BIDDERS BULLETIN

PROJECT: Hitchcock Co. Schools – 2012 Addition and Remodel
Culbertson and Trenton, Nebraska

BB-1

DATE ISSUED: January 20, 2012

Enlarged Plan

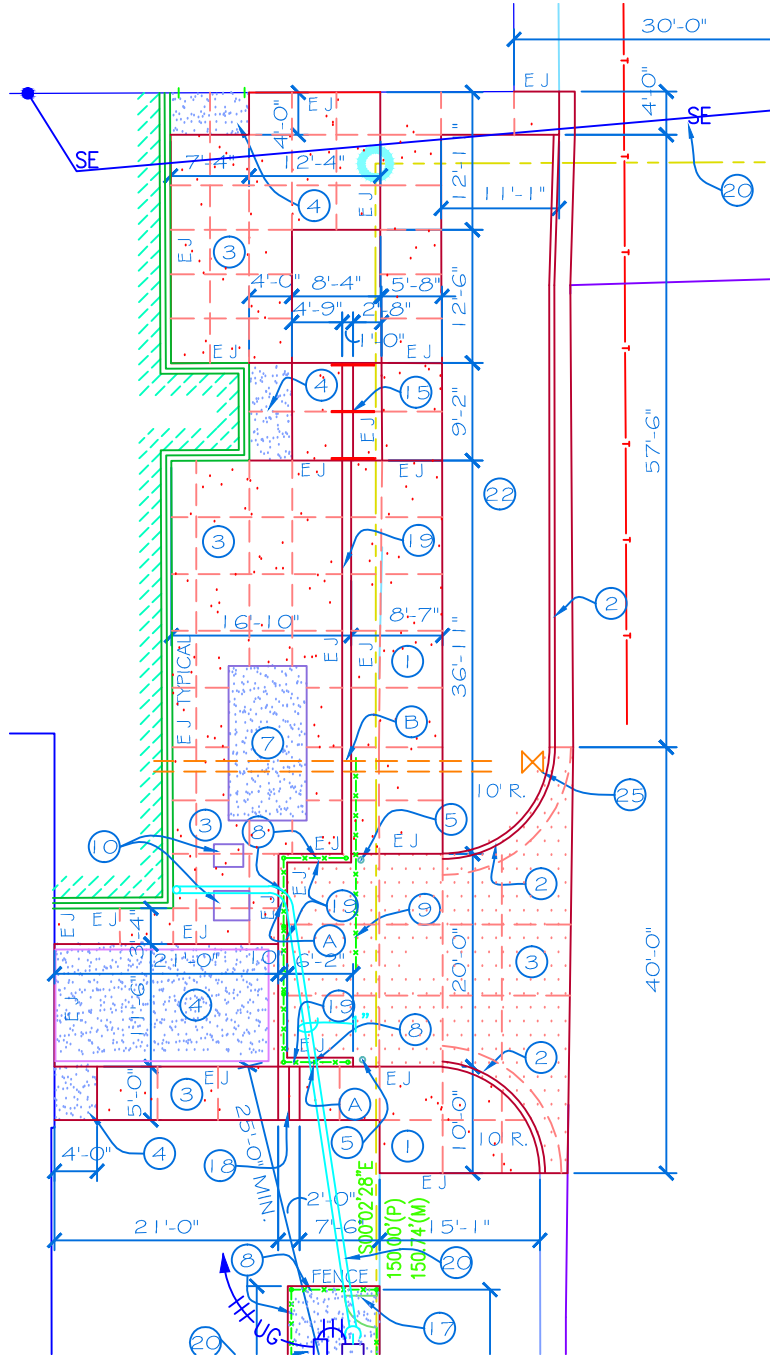
BB-1, ITEM #26: Drawing Sheet C101A and C101B – See supplemental sheet C101A-1 and C101B-2

- 1) Extend new curb paving northward as shown.
- 2) Add new Site Plan Note "A" to read: "Provide sleeves in retaining wall foundation for new propane gas line."
- 3) Add new Site Plan Note "B" building to read: "Extend drainage pipes underground to the east and through retaining wall foundation and under sidewalk to daylight between new sidewalk and new curb paving."
- 4) Add new Site Plan Note "C" to read: "Provide new splash blocks at new through wall downspout locations. See Mechanical and detail 11/C101B." The Site Plan Symbol will be located at the west wall of the new building addition.
- 5) Add new Site Plan Note symbols to plan as shown.

West Roof Drain Pipe Details

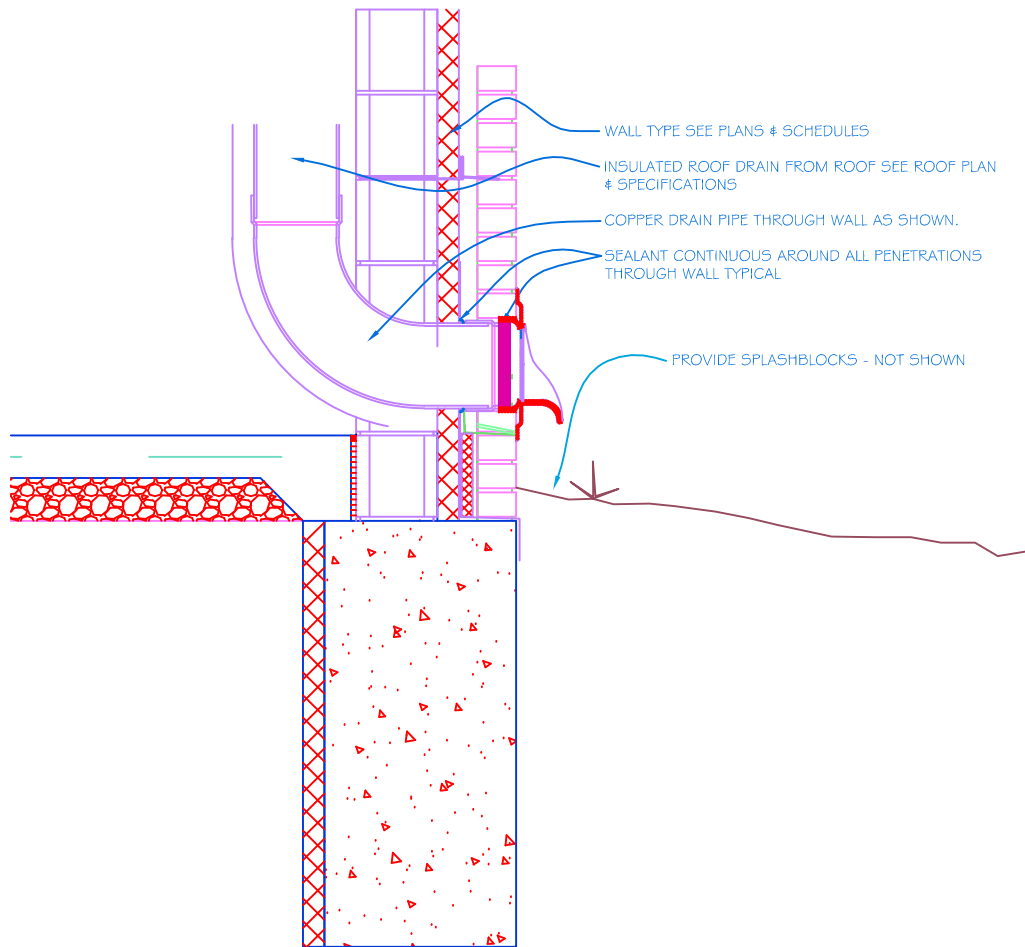
BB-1, ITEM #25: Drawing Sheet C101B – See supplemental sheet C101B-2

- 1) Revise Site Plan Note "17" at relocation area of existing bell north of existing north entry to be site plan note "23".
- 2) Add Site Plan Note "22" symbol on plan east of the existing south building between the new sidewalk paving and the new street curb.
- 3) Add new Site Plan Note "33" to read: "Paint face of exposed concrete riser with bright yellow street paint on three sides."
- 4) Add Site Plan Note "33" symbol on plan at 6" step west of room 127 Mech west wall.
- 5) Revise details D3, D4, D7 and D8 sheet numbers to be "C101B."
- 6) Details D3 and D7: Add note "(1) -#4 cont. at front edge of stair typical."
- 7) Add detail 11/C101B to sheet.

DRAWING: A100-1

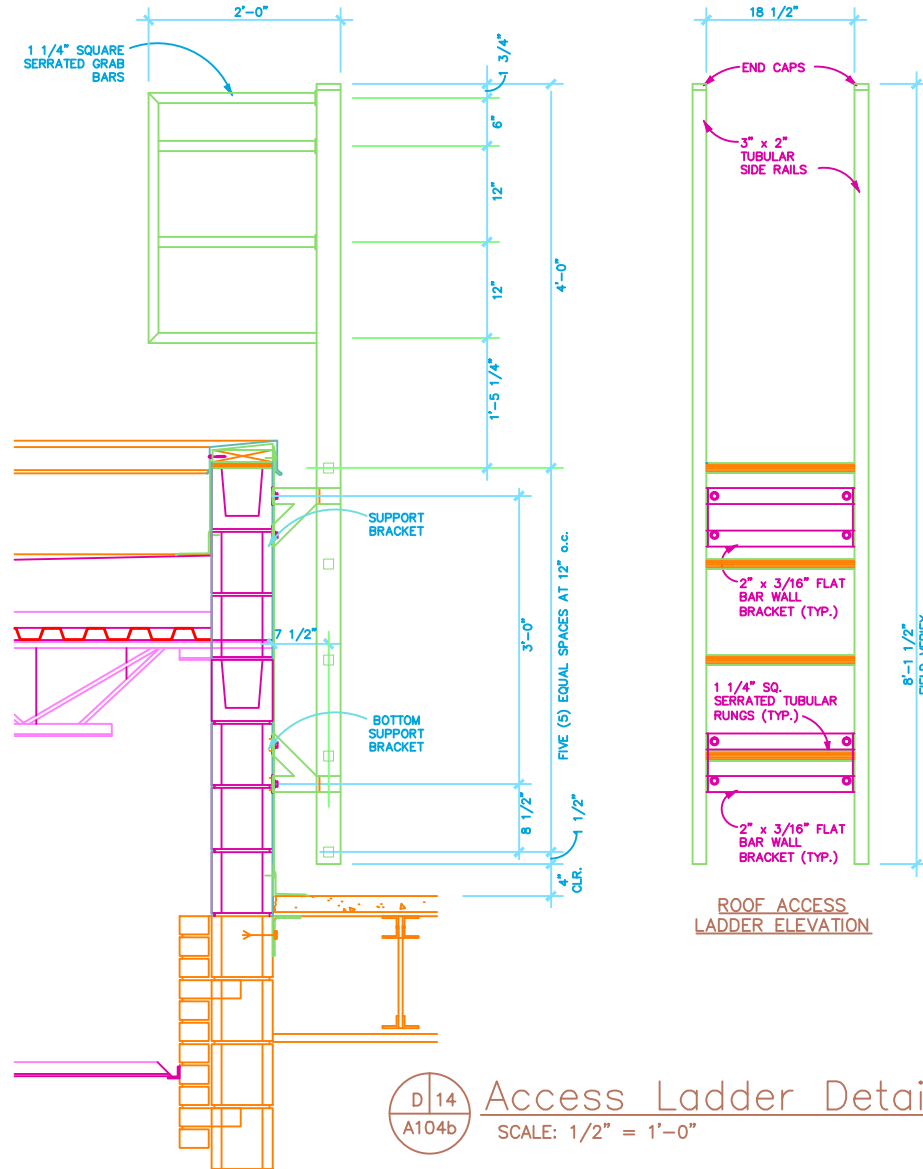
BB-1, ITEM #27: Drawing Sheet A100 – See supplemental sheet A100-1

- 2) Add Demolition Notes in their entirety. See supplemental drawing.

- 3) Add Demolition Note "22" symbol at north wall of existing room B106.
- 4) Add Demolition Note "23" symbol at east wall above double doors of the existing south building gymnasium.
- 5) Add Demolition Note "24" symbol at new mechanical room closets of the existing south building.
- 6) Add Demolition Note "25" symbol in room B110.
- 7) Add Demolition Note "26" symbol in all existing rooms to the south and to the east of the existing north building gymnasium.
- 8) Add Demolition Note "27" symbol in the existing room adjacent and on the north side of room 131.
- 9) Add Demolition Note "28" symbol at exterior south wall of existing north building.
- 10) Add Demolition Note "29" symbol at the center of room B100 Classroom.

D 14 Access Ladder Detail
A104b SCALE: 1/2" = 1'-0"

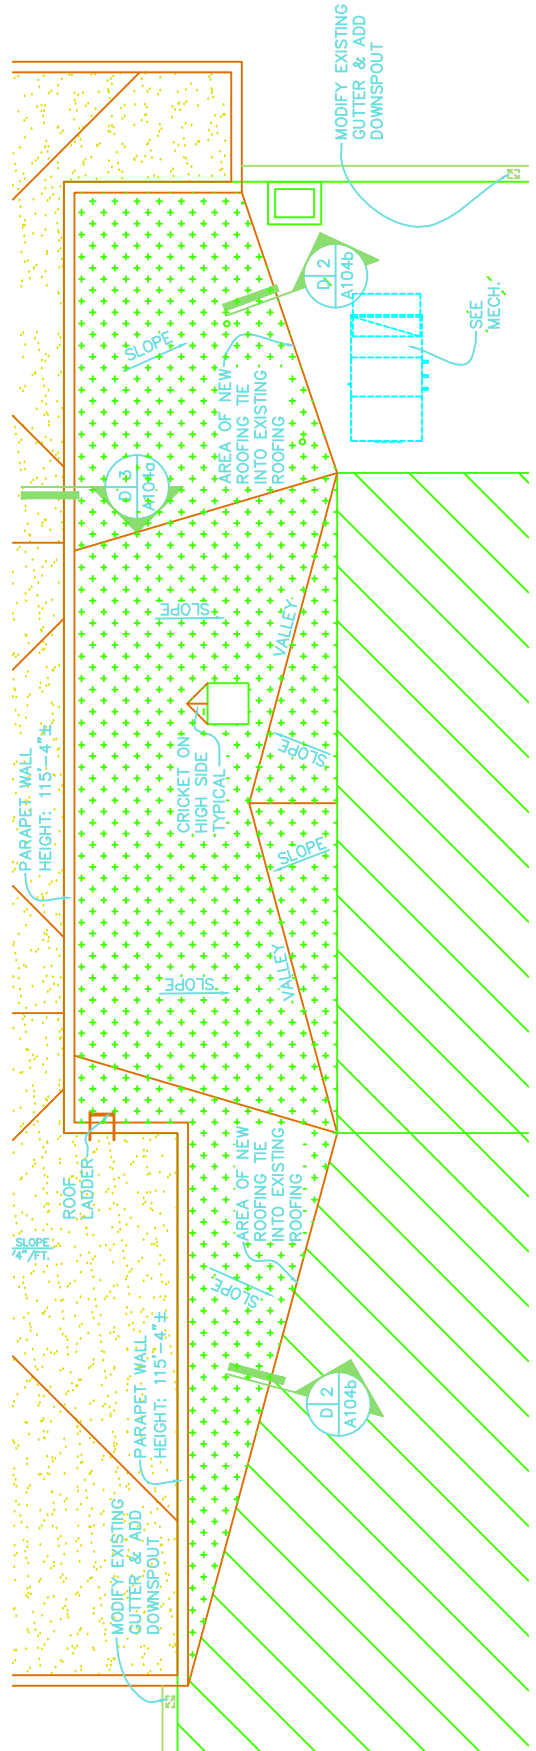
BB-1, ITEM #33: Drawing Sheet A104b – See supplemental sheet A104b-1

Revise detail D14 as shown.

Roof Plan
SCALE: 1/16" = 1'-0"

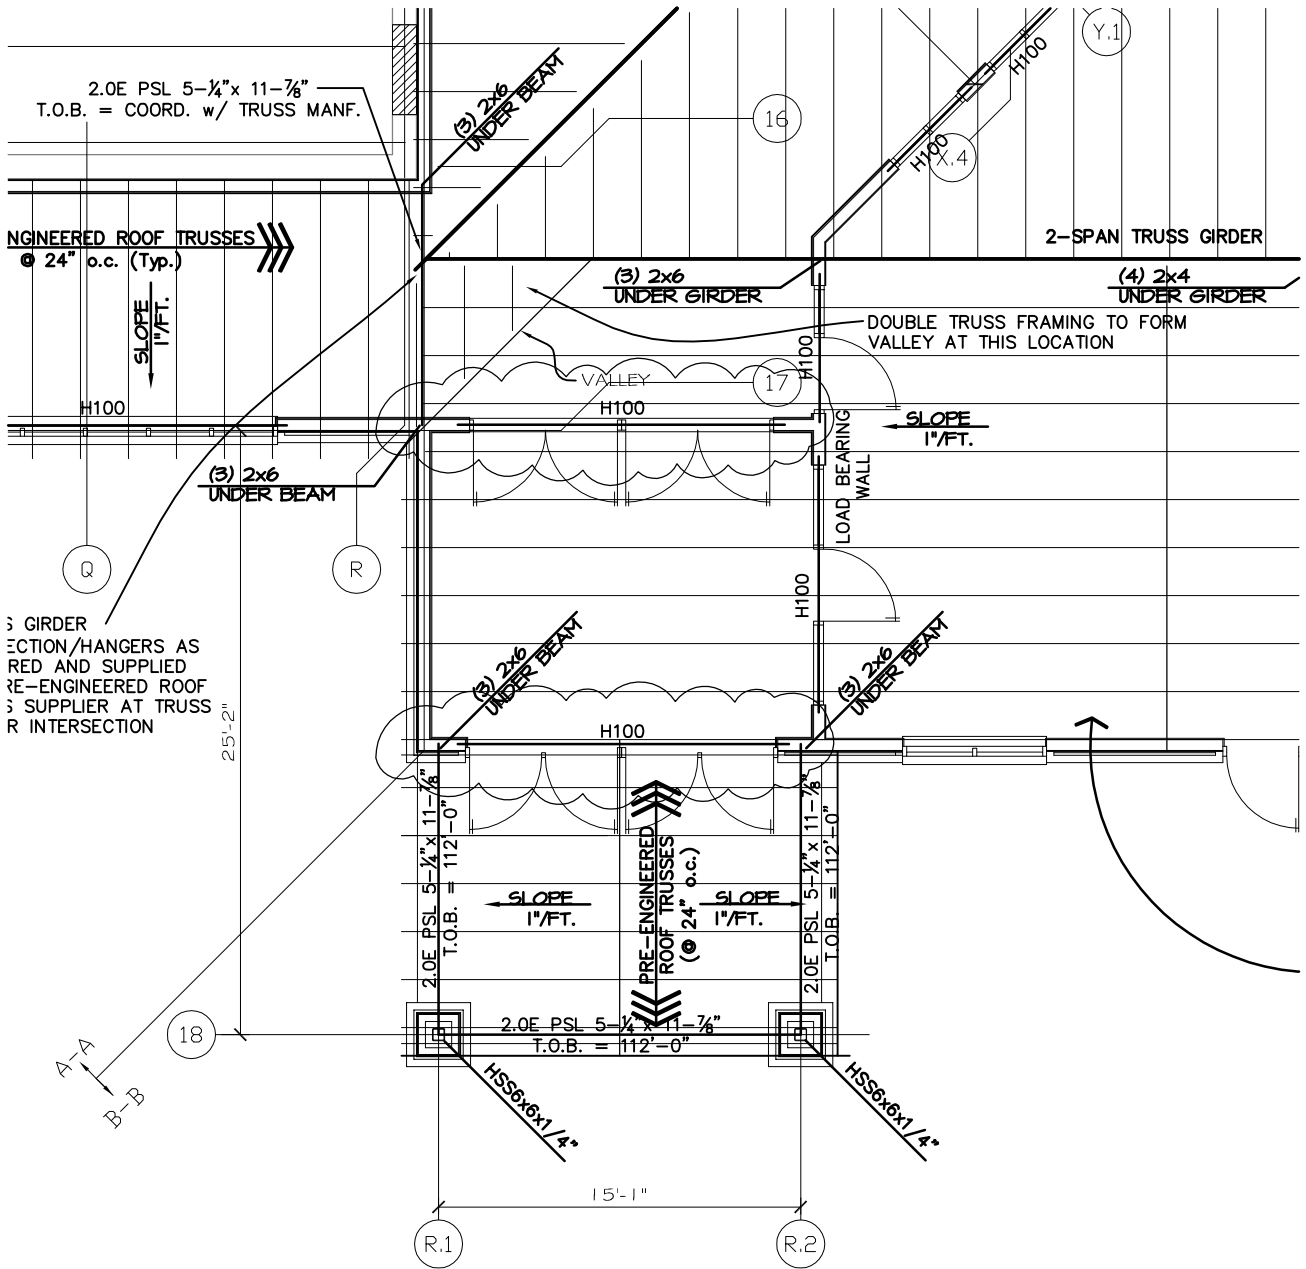
BB-1, ITEM #32: Drawing Sheets A104a and A104b – See supplemental sheet A104b-2

- 1) Revise roof plan at existing south building.
- 2) Omit new roof drains, overflow drains and piping from south building roof plan. See mechanical.
- 3) Relocate new downspout location at east wall of existing south building 24' further south. Adjust corresponding note to new location.
- 4) Provide new splash blocks at new downspout locations.

- 5) Add General Note "7" to read: "Patch and repair all areas of existing roof where mechanical demolition occurs and is not being replaced by new equipment. Roof patching to include new metal roof deck, new tapered rigid insulation and new roofing material to match adjacent surfaces. Coordinate with mechanical plans for locations."

01/18/2012
SHEET
M300
ATTACHMENT NO.
M1
JCT

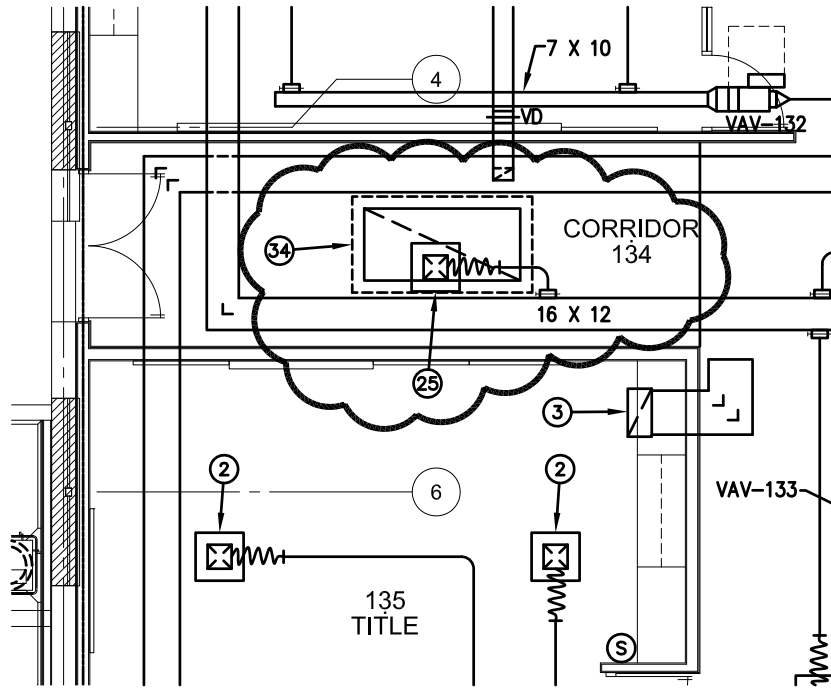
1. Sheet M200, Plumbing Plan – Area “A”:
 - A. Provide Class II standpipes on Stage 145 per requirement of NFPA 14.
2. Sheet M300, HVAC Plan – Area “A”:
 - A. See sheet M300 Attachment No. M1. New duct layout for RTU-1.

M2

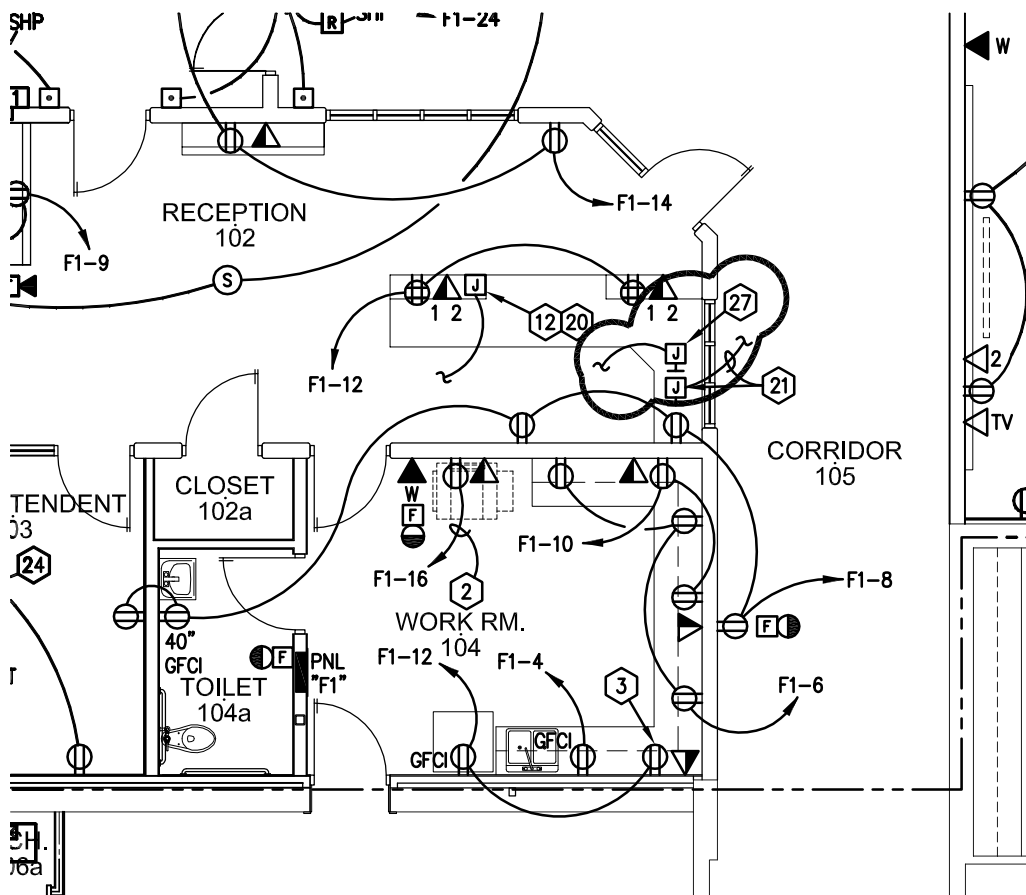
3. Sheet M301, HVAC Plan – Area “B” & “C”:
 - A. See sheet M301, Attachment No. M2. Relief air hood in Corridor 133 to be relocated to Corridor 134. New location of relief hood to be a minimum of 10'-0" away from roof edge. Relief air duct to penetrate into ceiling space. Provide drip pan as indicated in Relief Air Hood Detail on sheet M301.

E1

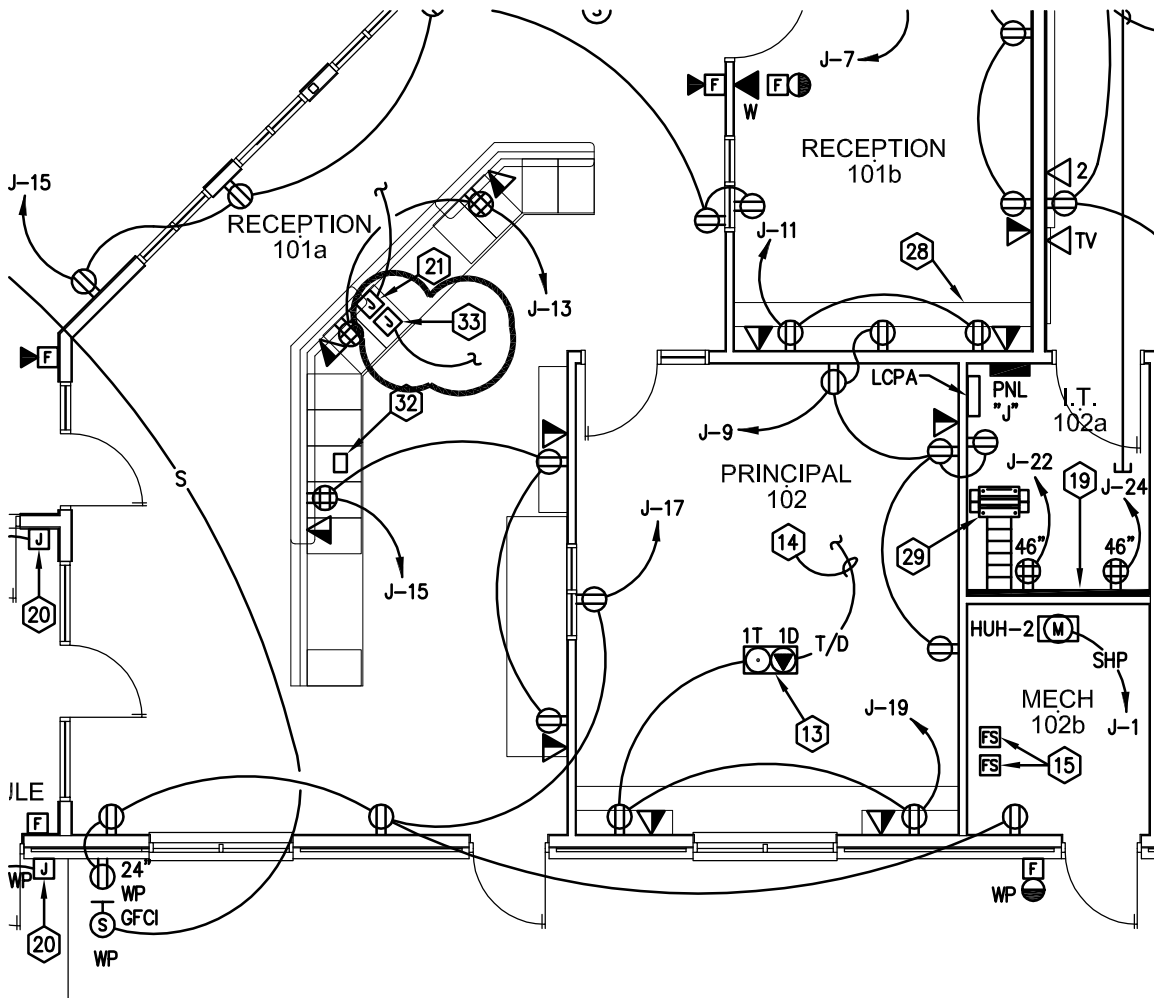
- A. Reception 102 - Add a box, complete with conduit and weather head for CB antennae, see attachment E1.
- 5. Sheet E301, Power Plan – Area "B"
 - A. See attached drawing "E4" for electrical revisions to classroom B104.

E301

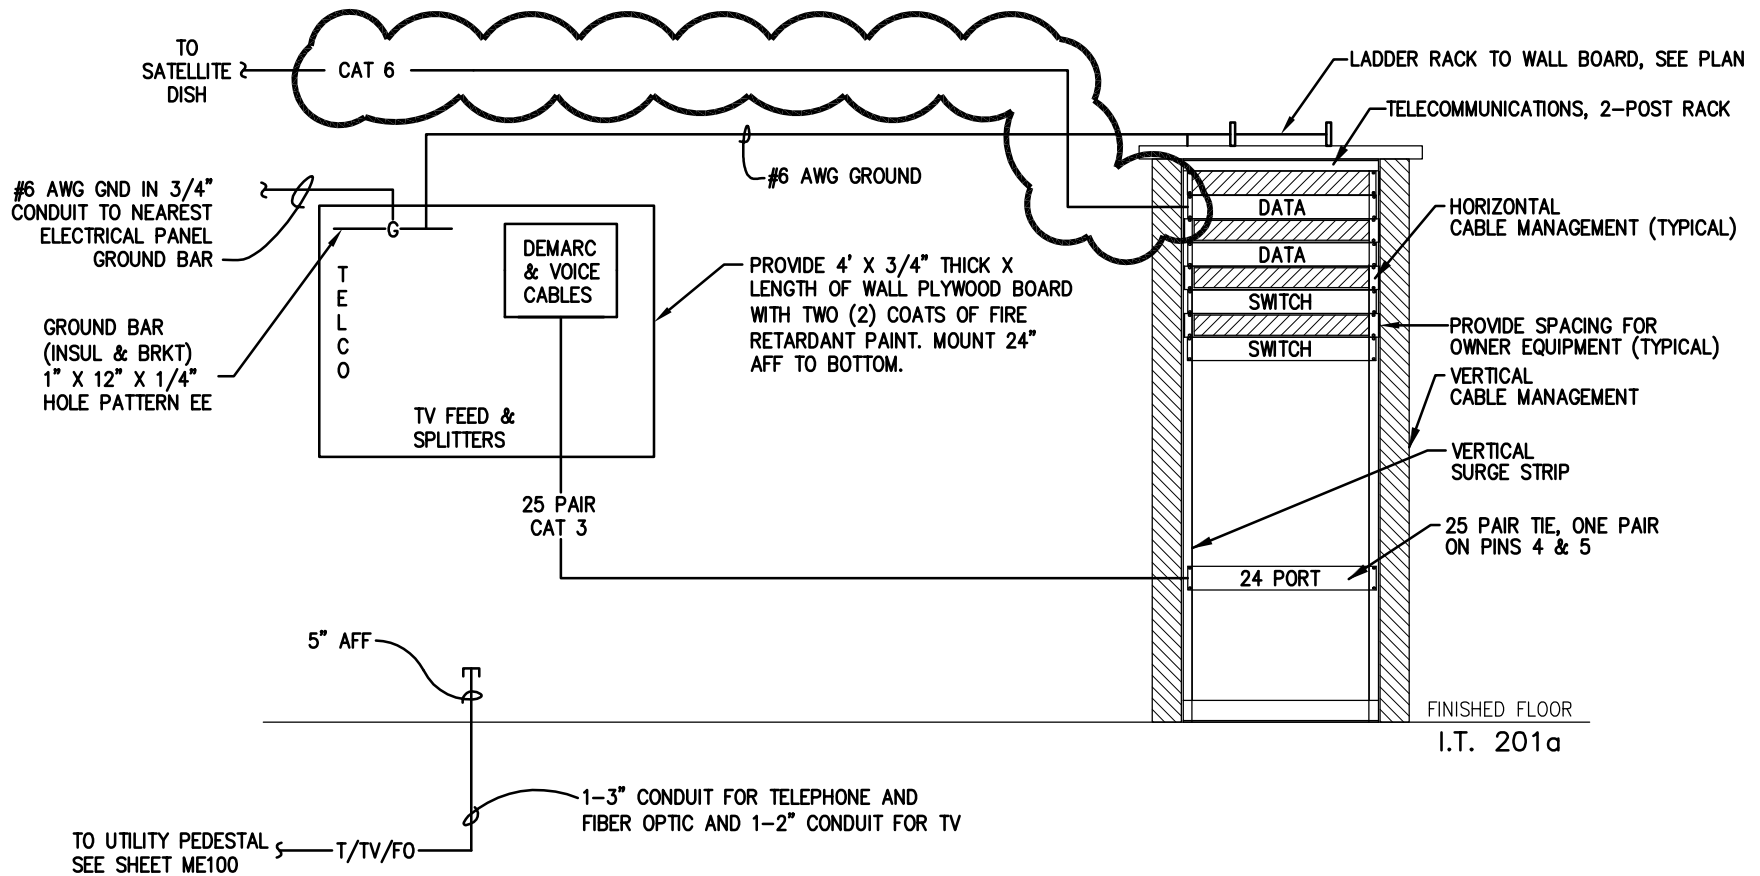
- 3. Sheet E301, Electrical Power Plan - Areas "B" and "C"
 - A. Reception 101a - Add a box, complete with conduit and weather head for CB antennae, see attachment E2.
